Public Comment No. 1655-NFPA 70-2024 [Global Input]

This Global Public Comment is for CMP-15 to review the use of the terms “overcurrent”, “overcurrent protective devices” and “overcurrent protection”.

Committee: NEC-P15

Figure 1

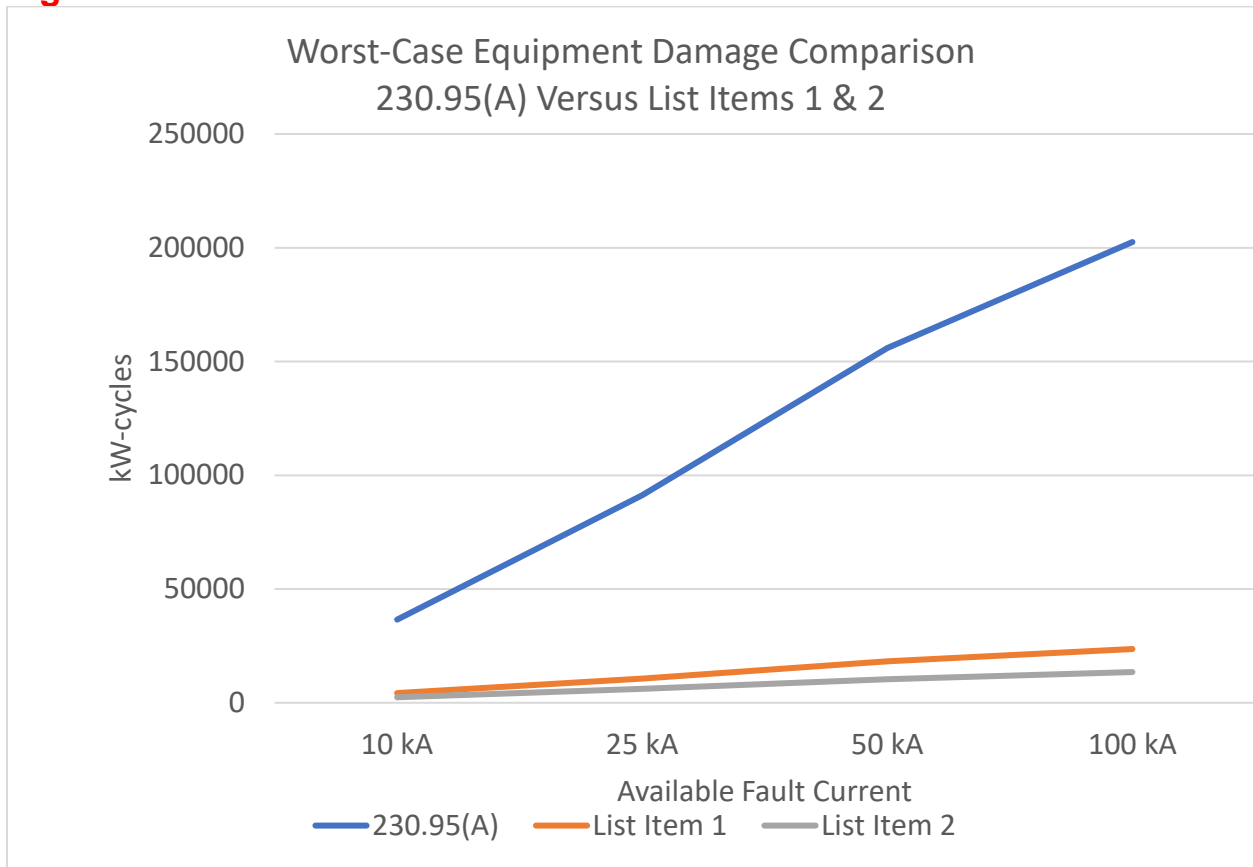
The IEEE 1584-2018 minimum arcing current is 6.09kA. Using the maximum 230.95(A) opening time of 60 cycles, the equipment damage is (6.09 kA X 60 cycles X 100 arcing volts) = 36,540 kW-cycles. See Figure 1.

The IEEE 1584-2018 minimum arcing current is 6.09kA. Assuming an opening time of 4 cycles for 240.87(B)(1), (B)(2), or (B)(4), the equipment damage is (6.09 kA X 4.0 cycles X 100 arcing volts) = 2,436 kW-cycles. Assuming an opening time of 3 cycles for 240.87(B)(5) or (B)(6), the equipment damage is (6.09 kA X 3 cycles X 100 arcing volts) = 1,827 kW-cycles. Worst-case damage for the minimum arcing current with this exception for circuit breakers (2,426 KW-Cycles) is less than 7% of the worst-case damage allowed by 230.95(A) (36,540 kW-cycles). See Figure 1.

Figure 1 shows that equipment damage allowed by this Public Comment is always, from 10,000 amperes available through 100,000 amperes available, just a small fraction of the equipment damage allowed by 230.95(A).

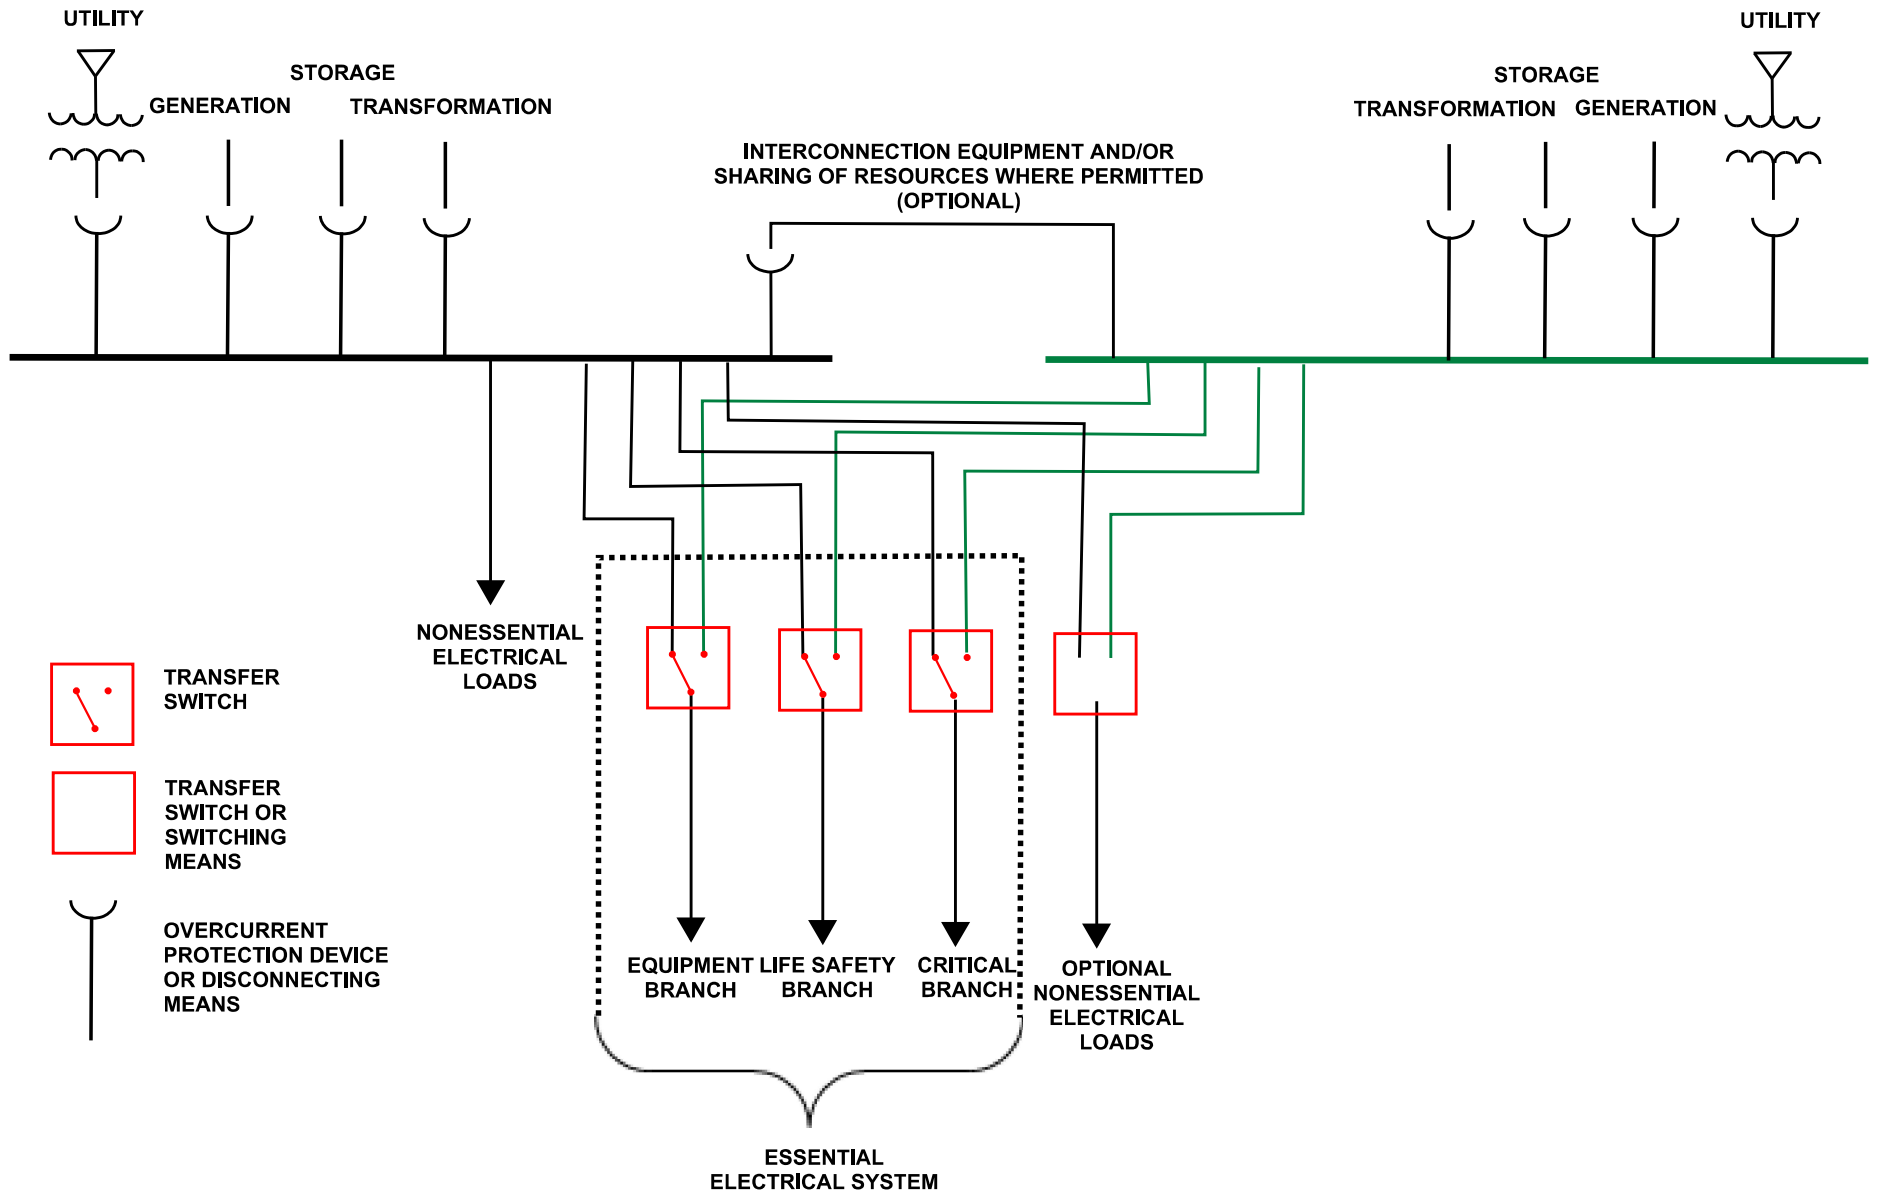
The current diagrams show some potential configurations that may be possible. The proposed diagram shows a more expansive view of what is possible, and is, therefore, more accurate. Also, this is the diagram that will go into NFPA 99. Sharing the same diagram between the two documents will greatly enhance correlation.

Figure Informational Note 517.31(B)(1) Type 1 EES — Minimum Requirement (Greater Than 150 kVA) for Transfer Switch Arrangement.

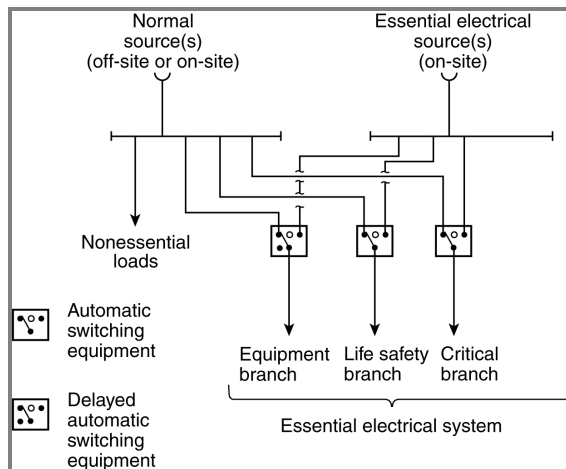
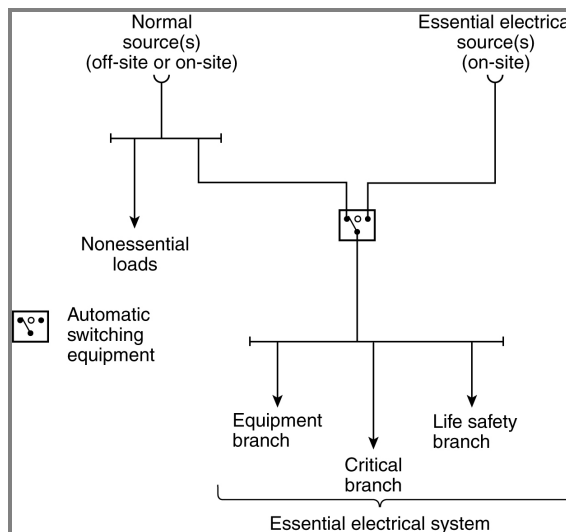
The original PI attempts to correct some language that could be misinterpreted to mean it is permissible to use multiple transfer switches that mix the branches as long as the load in each transfer switch is kept below 150kVA. The intent is to allow smaller facilities with small essential electrical systems to not have to divide the EES into separate branches. However, since the requirement is written based on the load on the transfer switch and not the total EES load, it could be allowable to mix the branches on a very large EES as long as the load on each individual transfer switch was kept below 150kVA. This could compromise the safety and reliability of key systems directly related to life safety and patient care.

This has also been proposed in NFPA 99 for correction. The challenge is that the NFPA 99 cycle trails the NFPA 70 cycle by one year. Since this is extracted language, it will automatically be updated once NFPA 99 is published. However, that would mean this incorrect language may remain in NFPA 70 until 2029. This comment attempts to reopen this discussion for the committee to consider the best path to correct this issue for both Type 1 EES (517.31(B)) and Type 2 EES (517.42(B)).

Figure Informational Note 517.42(B)(1) Type 2 EESs (Nursing Home and Limited Health Care Facilities) — Minimum Requirement (Greater Than 150 kVA) for Transfer Switch Arrangement.

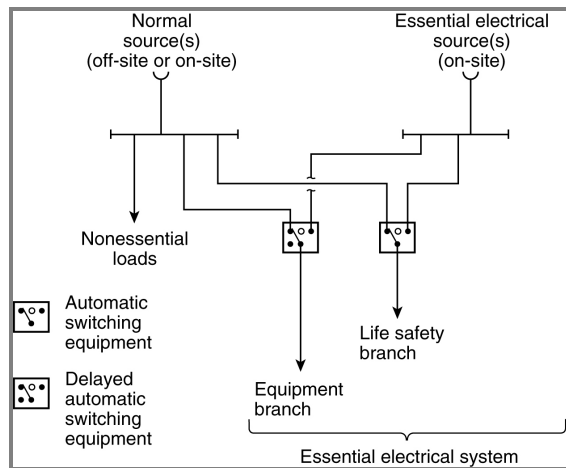
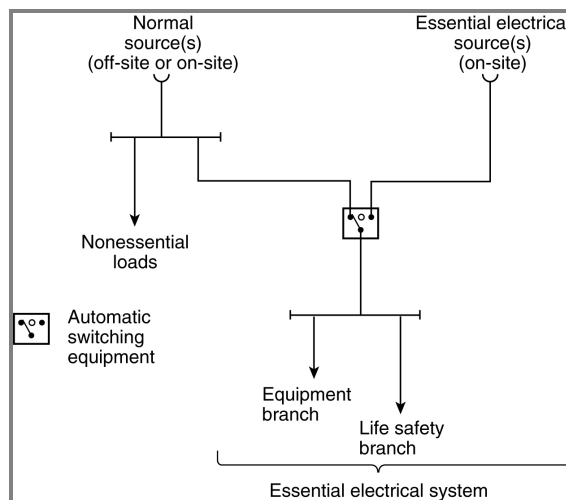
The original PI attempts to correct some language that could be misinterpreted to mean it is permissible to use multiple transfer switches that mix the branches as long as the load in each transfer switch is kept below 150kVA. The intent is to allow smaller facilities with small essential electrical systems to not have to divide the EES into separate branches. However, since the requirement is written based on the load on the transfer switch and not the total EES load, it could be allowable to mix the branches on a very large EES as long as the load on each individual transfer switch was kept below 150kVA. This could compromise the safety and reliability of key systems directly related to life safety and patient care.

This has also been proposed in NFPA 99 for correction. The challenge is that the NFPA 99 cycle trails the NFPA 70 cycle by one year. Since this is extracted language, it will automatically be updated once NFPA 99 is published. However, that would mean this incorrect language may remain in NFPA 70 until 2029. This comment attempts to reopen this discussion for the committee to consider the best path to correct this issue for both Type 1 EES (517.31(B)) and Type 2 EES (517.42(B)).
